# Access Compliance Report

## Public Rights-of-Way

### (Pedestrian Signals)

Intersection ID: N/A	Main Street:	Cross Street: N/A	Location: N/A
ADA ID: 8DE000C14056	Signal Type: Two Push Buttons-Non APS	Overall Compliance: No	Severity Score: BTN 1:N/A BTN 2: N/A No BTN: N/A
Codes/Mitigation Info/Possible Solution		Field Measurements/Component Compliance

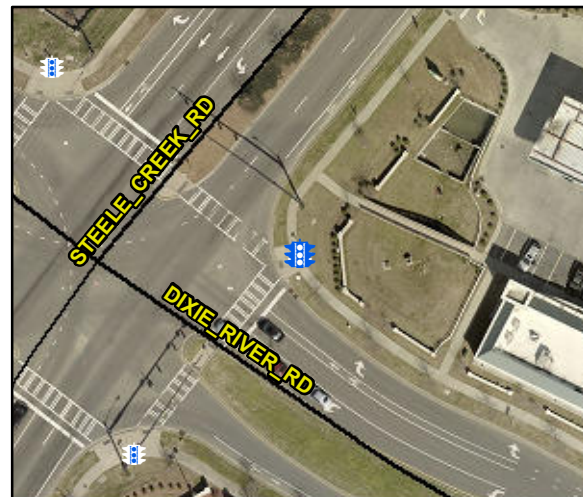
Possible Solutions: Replace Signal Push Button With APS Button on New Post. Remove & Relocate Sign.

PROW/ADA: TMUTCD 4e.08, R404.2, R406.2

Yes	B 1 Clear Xing Direction?	ClearlyMarked	Yes	B 2 Clear Xing Direction?	ClearlyMarked
	B 1 Crossing Direction	To NW		B 2 Crossing Direction	To SW
No	B 1 DistanceTo XWalk (in)	85.0	Yes	B 2 DistanceTo XWalk (in)	6.0
No	B 1 DistanceTo Curb (in)	165.0	No	B 2 DistanceTo Curb (in)	165.0
Yes	B 1 Diameter (in)	2.0	Yes	B 2 Diameter (in)	2.0
